LiDAR Quality Assessment Report

OR_PoleCreek_2013

Statement of Work (SOW): Reference C.1 of the Contract. This **Pole Creek 8ppsm Lidar Task Order** is for Planning, Acquisition, processing, and derivative products of lidar data to be collected at a nominal density of 8 points per square meter (ppsm). Specifications listed below are based on the "**National Geospatial Program Lidar Base Specification Version 1.0**", which is incorporated by reference to this task order. This specification may be viewed at <http://pubs.usgs.gov/tm/11b4/>. These lidar specifications are required minimum baseline specifications. In addition to the Specification Requirements, this task order shall meet NEEA QL1. For any item which is not specifically addressed, the referenced Specification Version 1 will be the required specification authority. This task is for lidar for a **very high resolution data set of lidar of approximately 86 total square miles, located North East of Bend Oregon.**

Checkpoint Distribution Image

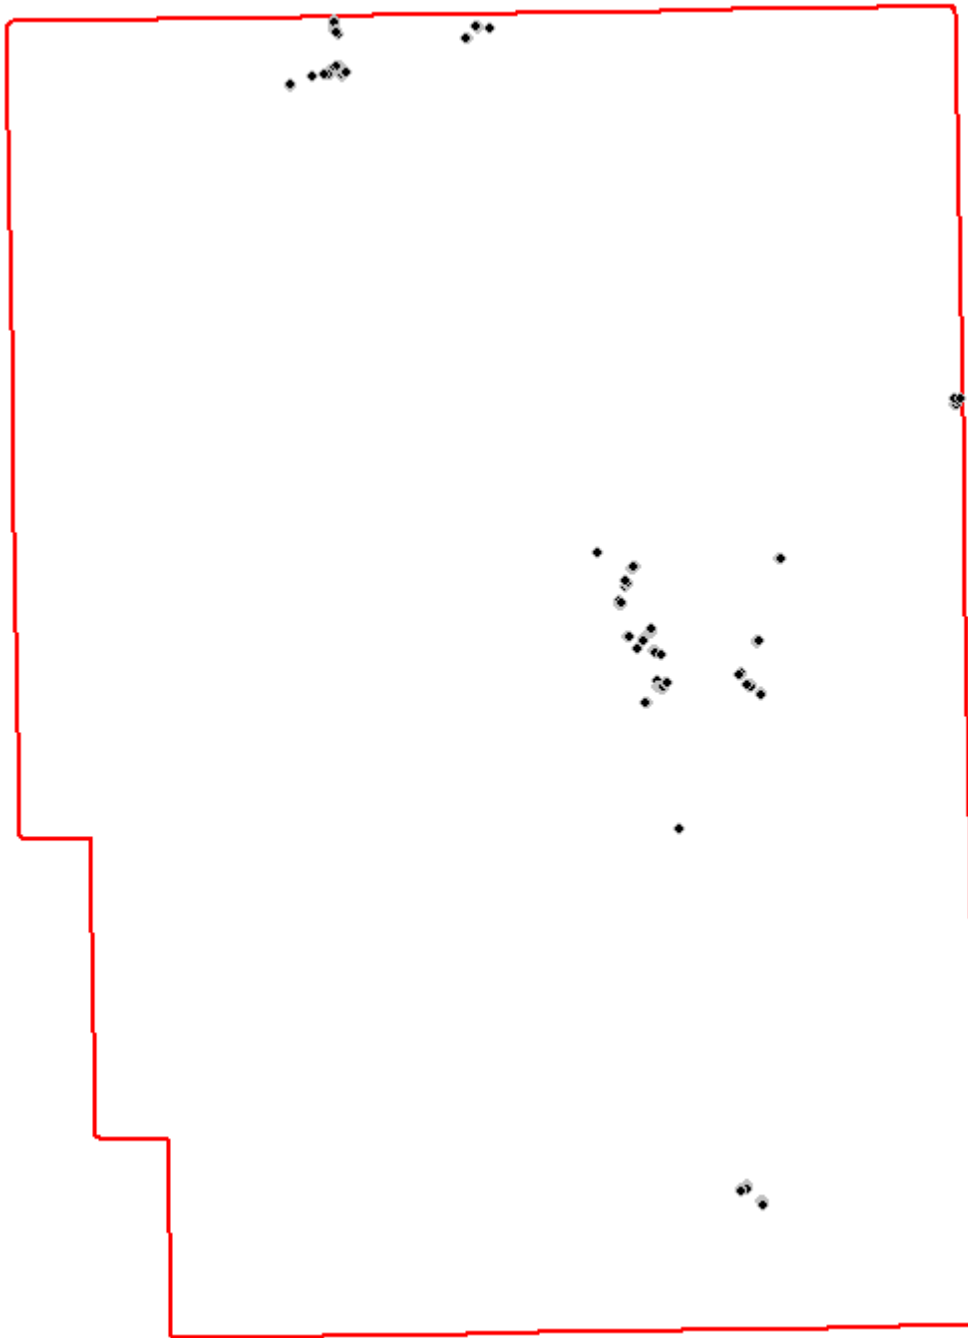
Vertical Accuracy Results:

56 control points were tested for the BARE_EARTH class

142 total control points were tested

The Skew for all control points is 0.422475878
 The Kurtosis for all control points is 0.920719288135
 The RMSEz for all control points is 0.0806374640733 Meters
 The NSSDA AccuracyZ (=RMSEz*1.96) for all control points is 0.158049429584 Meters at the 95% Confidence Level
 The Consolidated Vertical Accuracy (CVA) at the 95th percentile for the dataset is 0.167916243523 Meters

Based on this review, the USGS accepts the vertical accuracy.
